**A. ADMINISTRATIVE SITE PLAN REPORT & DECISION**

**Project Name:** Sunset Terrace Development – Building I

**File Number:** LUA15-000159, SA-A

# EXHIBIT 4

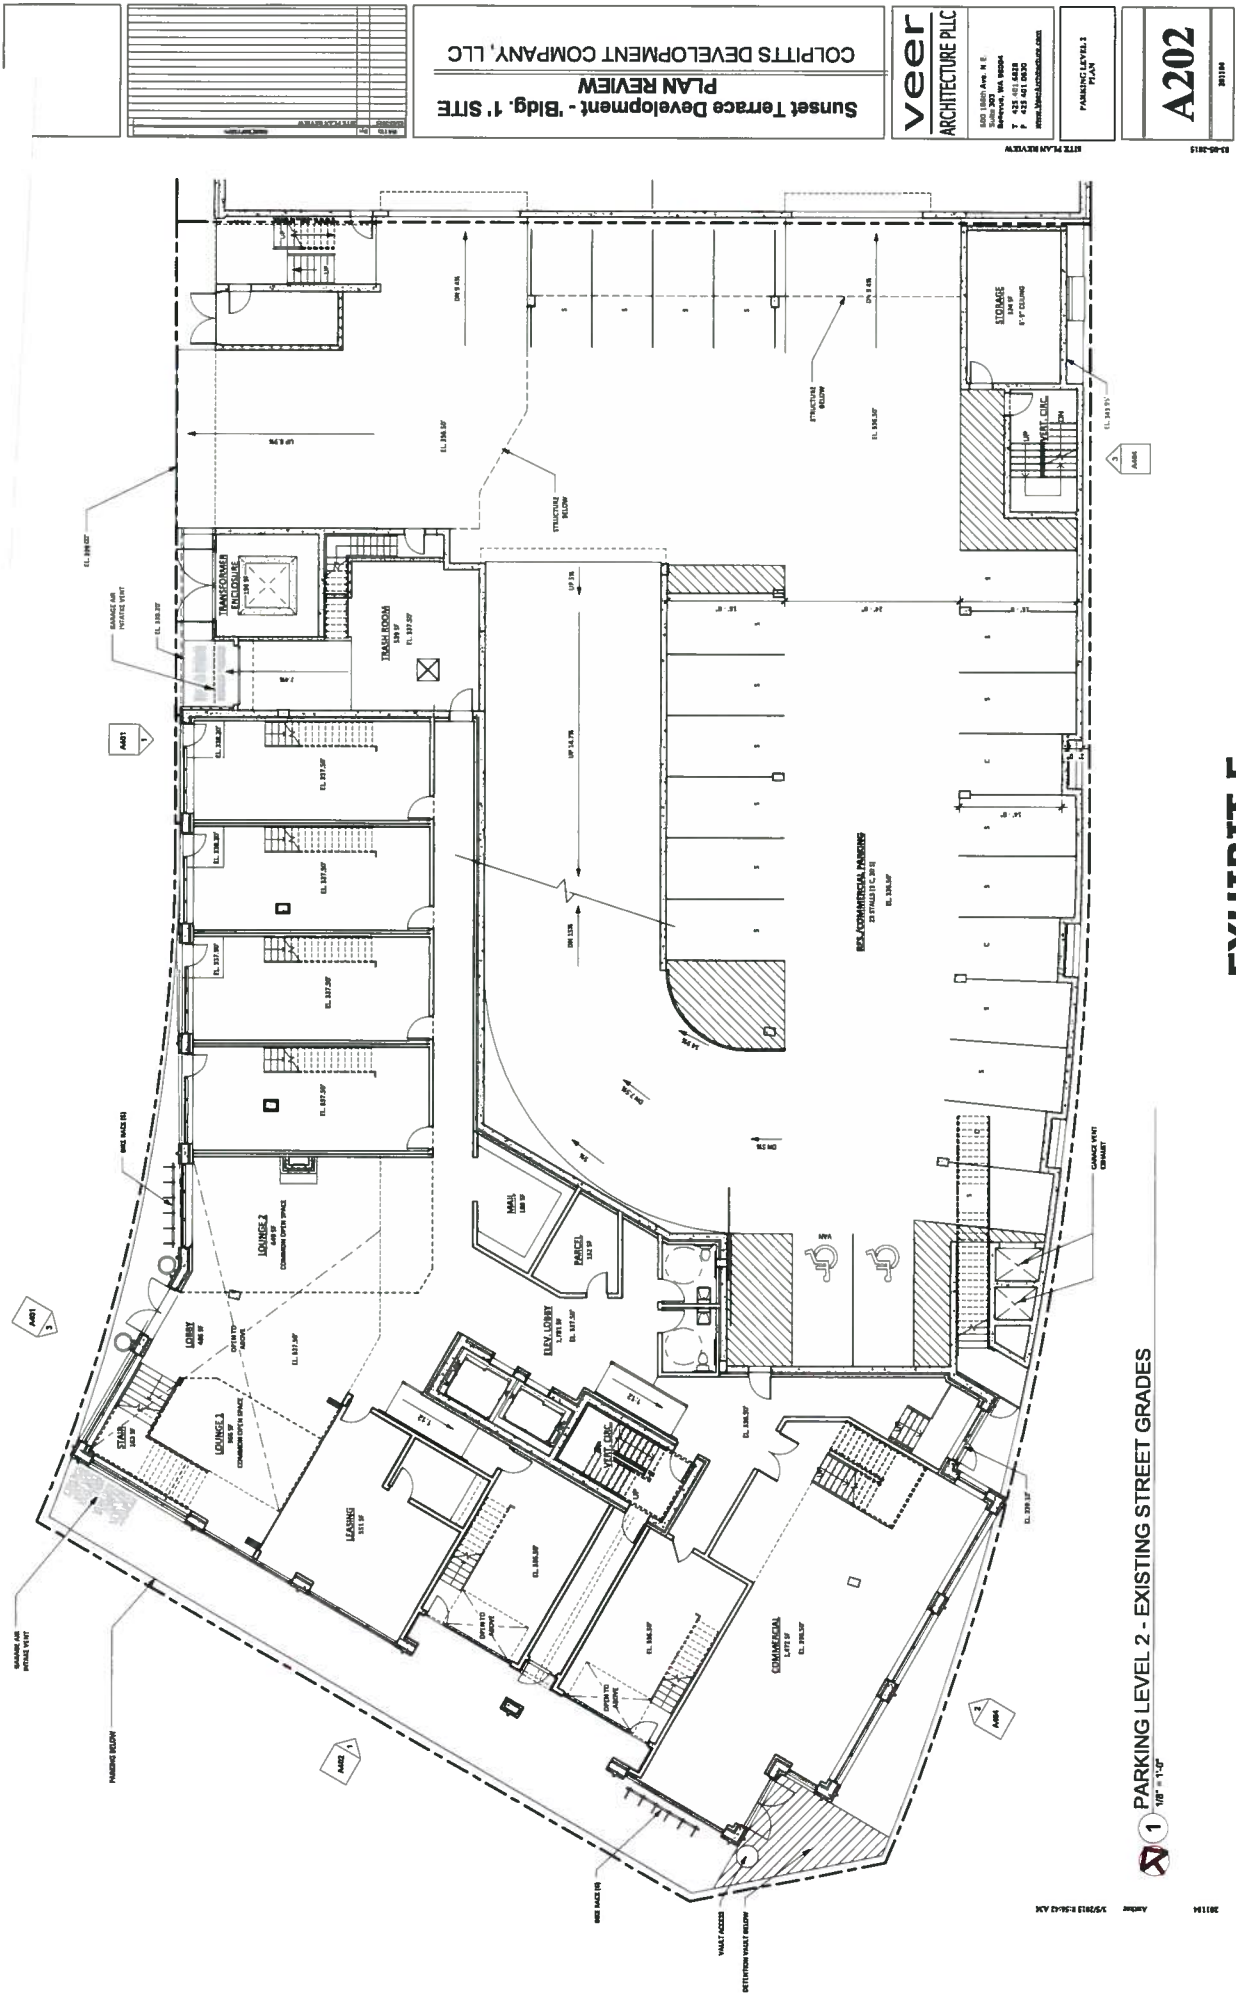
<p>Therefore staff recommends a condition of site plan approval, requiring the applicant revise the ground floor along NE Sunset Blvd to include additional commercial uses with windows, doors/entries, building modulation, and other architectural detailing. The revised, elevation shall be submitted to, and approved by, the Current Planning Project Manager prior to building permit approval.</p> <p>In expectation of the recommended condition, the applicant submitted revised elevations along NE Sunset Blvd following the submittal of the subject application (Exhibit 18). Staff determined proposed elevation revisions addressed staff's concerns and would serve to eliminate blank walls within the reduced setback along NE Sunset Blvd. Should the revised, or comparable, elevations be submitted as part of a building permit application staff would be supportive of the reduced setback from 10 to 0 feet.</p>

2. The applicant shall revise the ground floor along NE Sunset Blvd, as depicted in Exhibit 4, to include additional commercial uses with windows, doors/entries, building modulation, and other architectural detailing. The revised, elevation shall be submitted to, and approved by, the Current Planning Project Manager prior to building permit approval.

7. The applicant shall revise the elevations to create a visually prominent entrance and/or distinctive gateway element at the intersection of NE Sunset Blvd and Harrington Ave NE. The revised elevation shall be submitted to, and approved by, the Current Planning Project Manager prior to building permit
